Access Compliance Report

Public Rights-of-Way

(Curb Ramps)

| Intersection ID: 13635 | Main Street: E_BLAND_ST | Cross Street: SOUTH_BV | Location: NW |

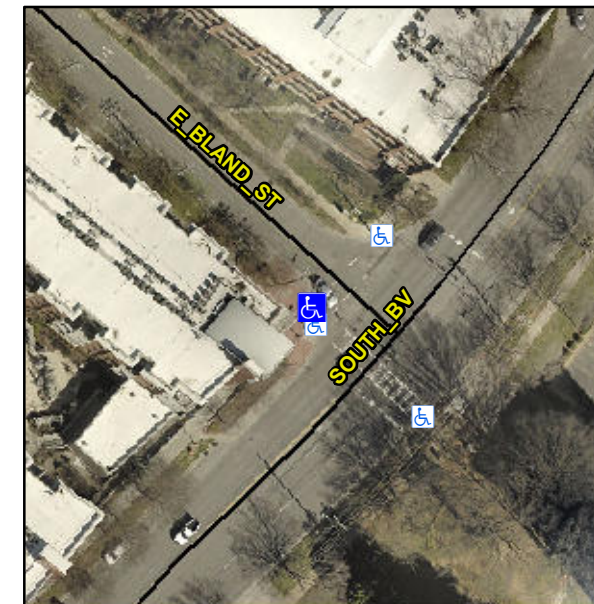
| ADA ID: 72711D3B000E | Ramp Type: Perp | Initial Pass/Fail: Fail | Overall Compliance: No |

R304.5.1, R304.2.2, R304.5.3

| Compliance | Description | Data | Compliance | Description | Data |
|------------|-----------------------|-------|------------|-----------------------------|------|
| N/A | Ramp Length (in) | 90.0 | No | Ramp Slope (%) | 10.3 |
| No | Ramp Width (in) | 46.0 | No | Ramp XSlope (%) | 5.1 |

Remove & Replace Entire Ramp.
